UNITED STATES PATENT AND TRADEMARK OFFICE

APPLICATION NO.	FILING DATE	FIRST NAMED INVENTOR	ATTORNEY DOCKET NO.	CONFIRMATION NO.
10/574,425	04/04/2006	Hans Lindh	P/1830-19	7893

Office Action Summary

DETAILED ACTION

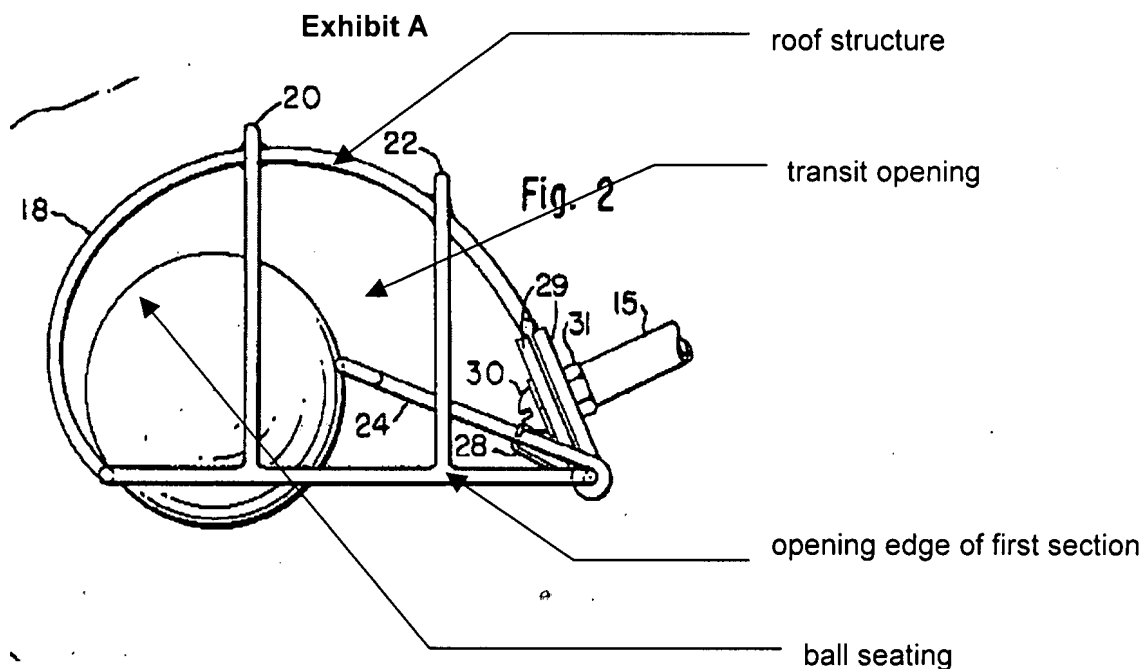
11. Claims 1,2, and 4, as best understood, are rejected under 35 U.S.C. 102(b) as being anticipated by Christle (3,046,044).

Christle (3,046,044) discloses a golf ball retrieval device comprising an elongated handle 12, a cage (Fig. 2), having a first section and a second section, the first section having an opening edge (see Exhibit A), a transit opening which connects the first section and the second section and which forms a threshold over which the ball go through, the second section having a downwardly open opening forming a ball seating, and a roof structure.

Re claim 2, Exhibit A shows the threshold in combination with a member 24 capable of preventing the ball from rolling from the ball seating.

Re claim 4, the ball seating in combination with a member 24 is capable of being in a position in which the center of gravity of the ball lies beneath the axis of the handle 12 in a second orientation of the cage, where the cage has been rotated about the axis through an angle of 180 degrees.
